**CITY OF TEMPE  
DEVELOPMENT REVIEW COMMISSION**

**Meeting Date: 02/11/2014  
Agenda Item: 5**

**ACTION:** Request for a Development Plan Review consisting of a new drive thru restaurant building for CULVERS RESTAURANT located at 630 East Southern Avenue. The applicant is Evergreen Devco.

**DEVELOPMENT PROJECT FILE**  
for  
**CULVER'S RESTAURANT**

SHEET TITLE: **CONCEPTUAL LANDSCAPE PLAN**

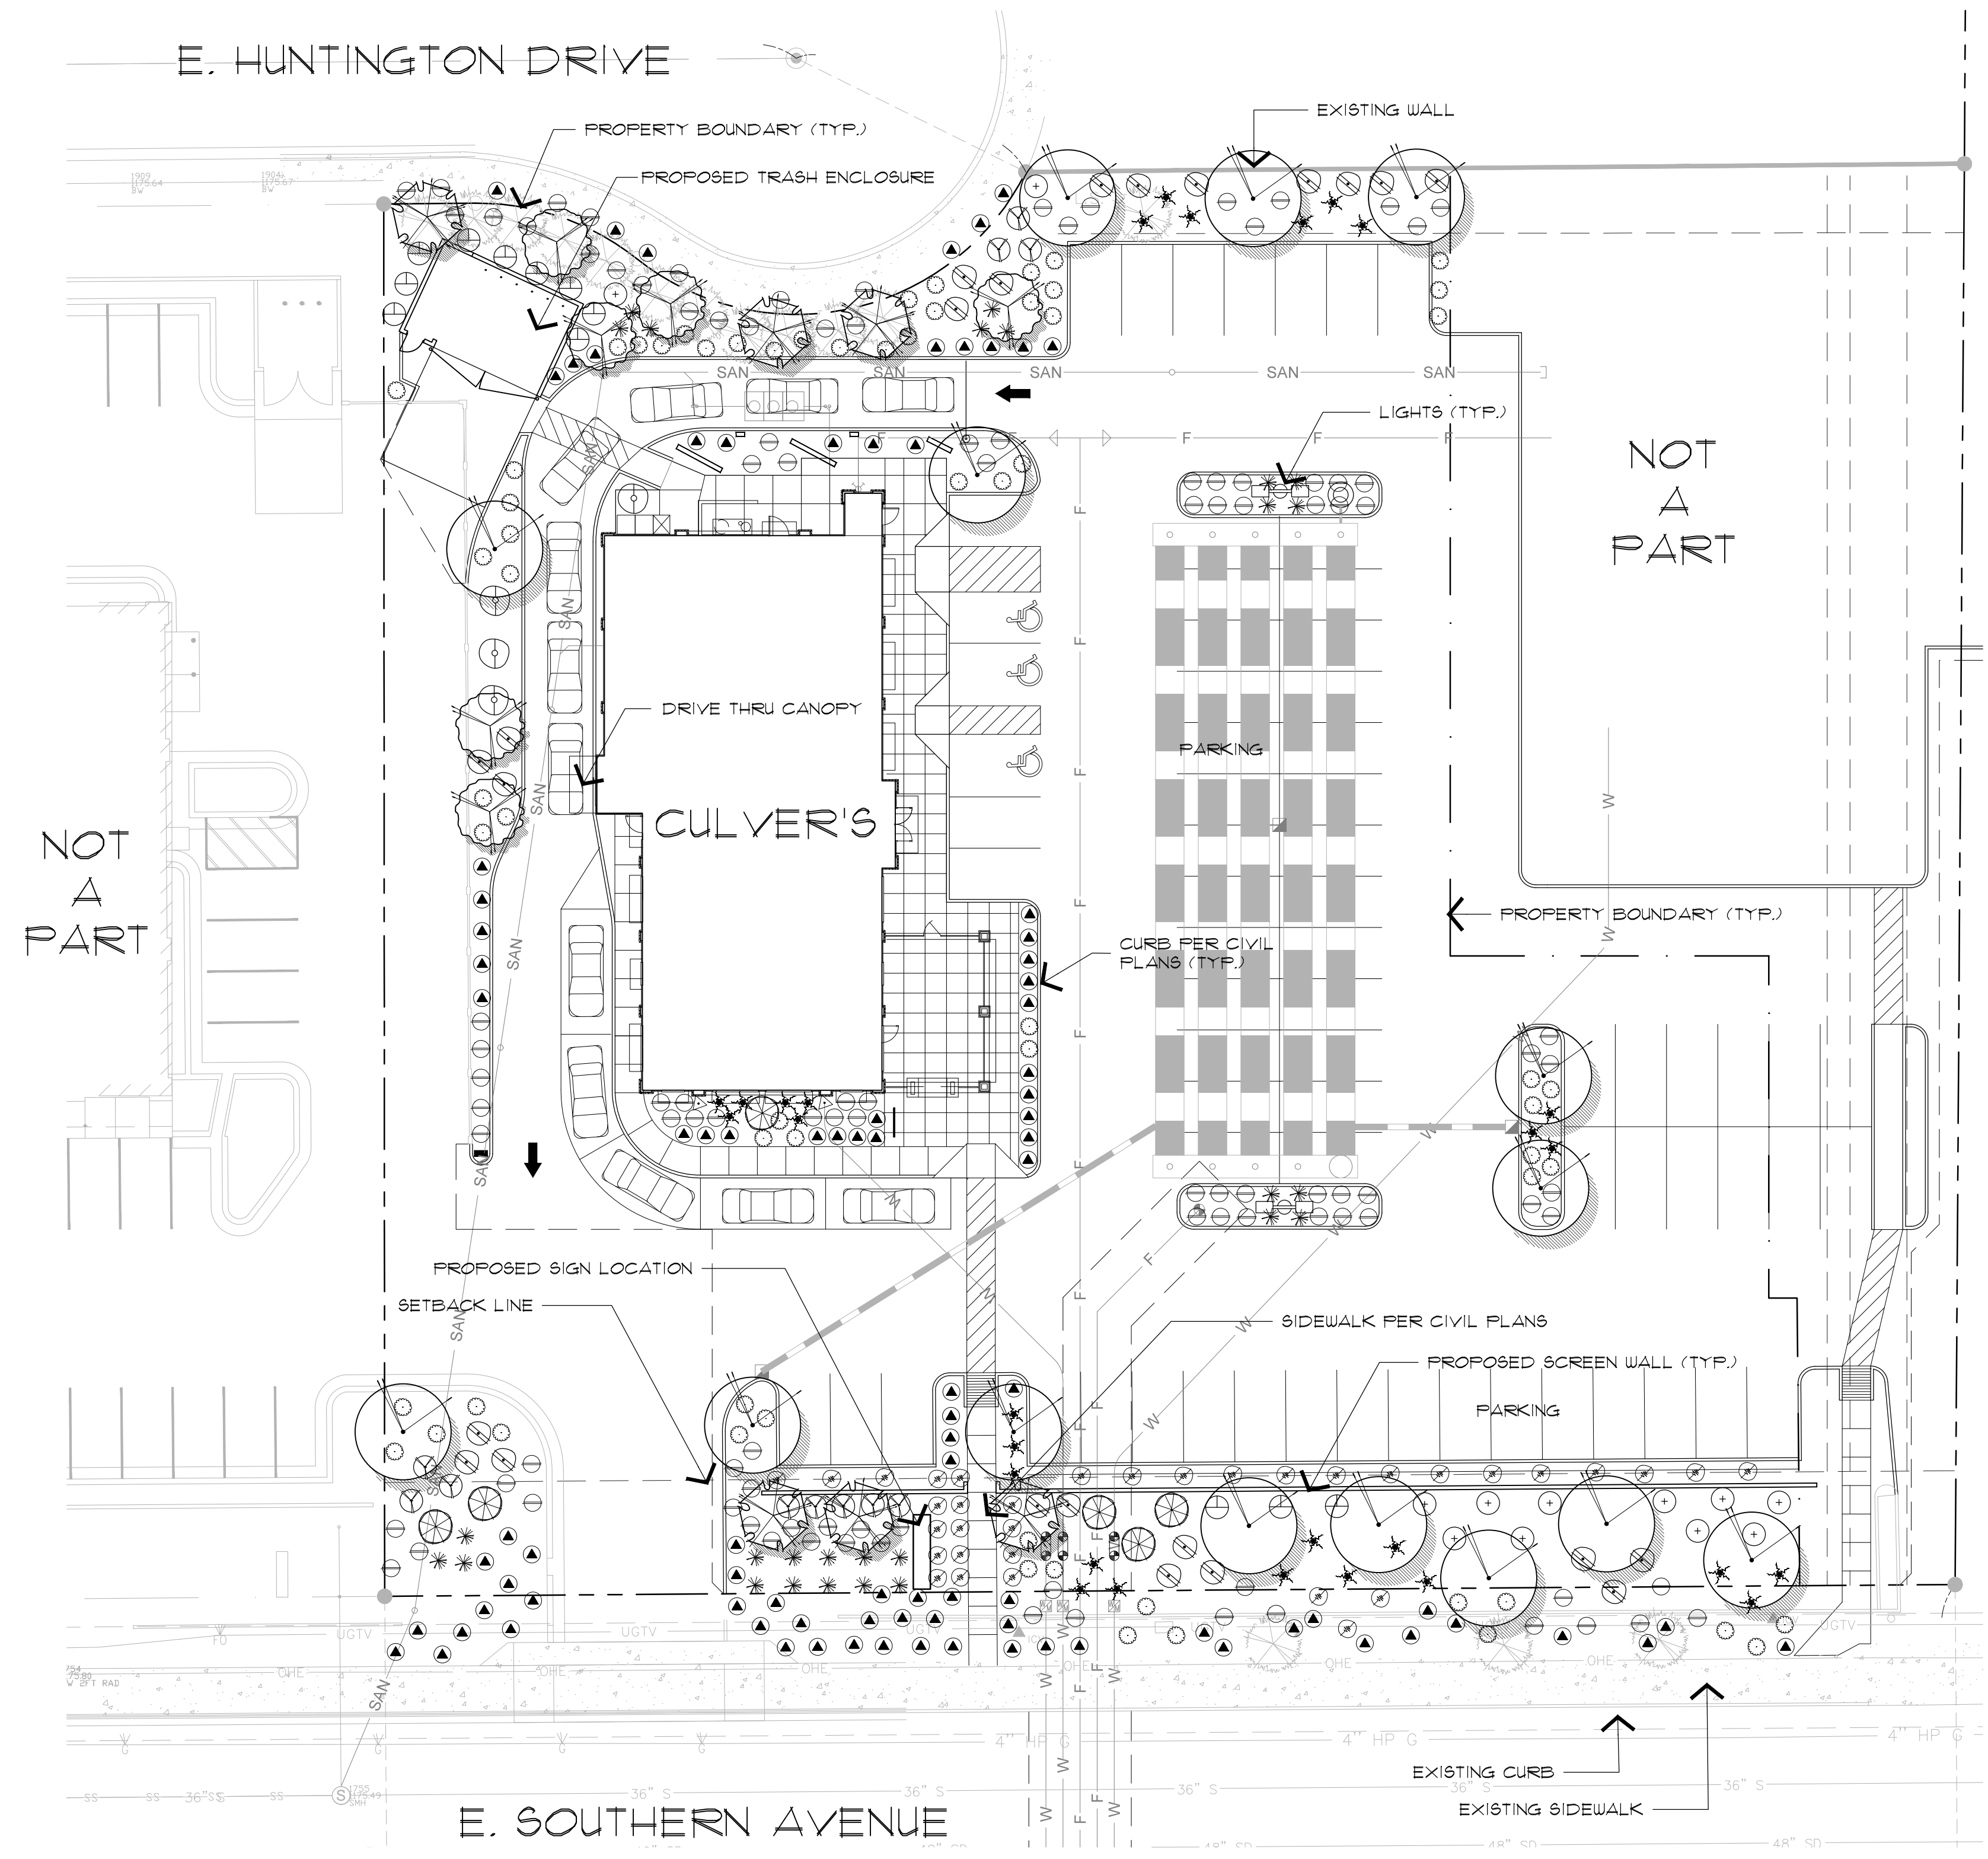
8. The plant palette is approved as proposed and specified on the landscape plan. Any additions or modifications may be submitted for review during building plan check process. Provide canopy trees in landscape islands per ZDC minimum requirements.

10. Top dress planting areas with a rock or decomposed granite application. Provide rock or decomposed granite of 2" uniform thickness. Provide pre-emergence weed control application and do not underlay rock or decomposed granite application with plastic.
